## PART 21 REPORT - DEVIATION OF HK CIRCUIT BREAKER CLOSE LATCH SPRING

**Subject: Amendment to Previous 10CFR Part 21 Notification of Deviation re. HK Circuit Breaker  
Close Latch Spring**

Figure 1 - Closing Latch Spring

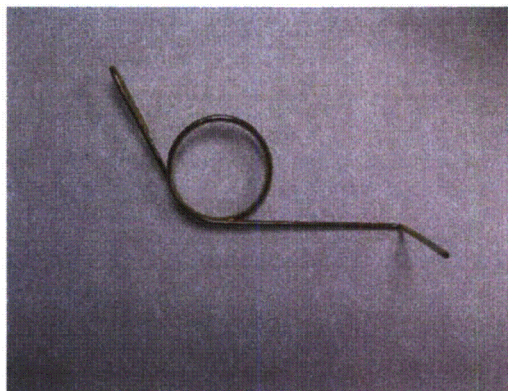
This letter amends the previous 10CFR Part 21 Notification of 31 July 2013 to encompass a wider time period during which the close latch spring (P/N: 162374A00) was sold for use in medium voltage HK circuit breakers. The initial time period of concern reported was January 2010 to July 2013. Revision 7 to the print was issued in January 2010 and it was determined during the initial investigation that this was the start of the deviation because the free angle was incorrectly shown. Our corrective actions in 2013 corrected this mistake.

4. Nature of the deviation: The close latch springs provided during the reported time period have acceptable dimensional, material type and finish critical characteristics; however a sampling of springs were found to be as much as 34% lower initial moment and as low as 18% lower final moment relative to the nominal requirements of the master drawing. There is a potential for an aged HK circuit breaker with hardening grease (towards the end of the ABB 10-year recommended maintenance periodicity) and this reduced spring force not to close when commanded. No field failures or shop failures of this closing latch spring have been identified.

- f. Revised part number 162374A00 spring drawing to revision 8 to include a larger free position angle. (Action complete)
  - g. Notified all customers affected from January 2010 to present. (Action Complete)
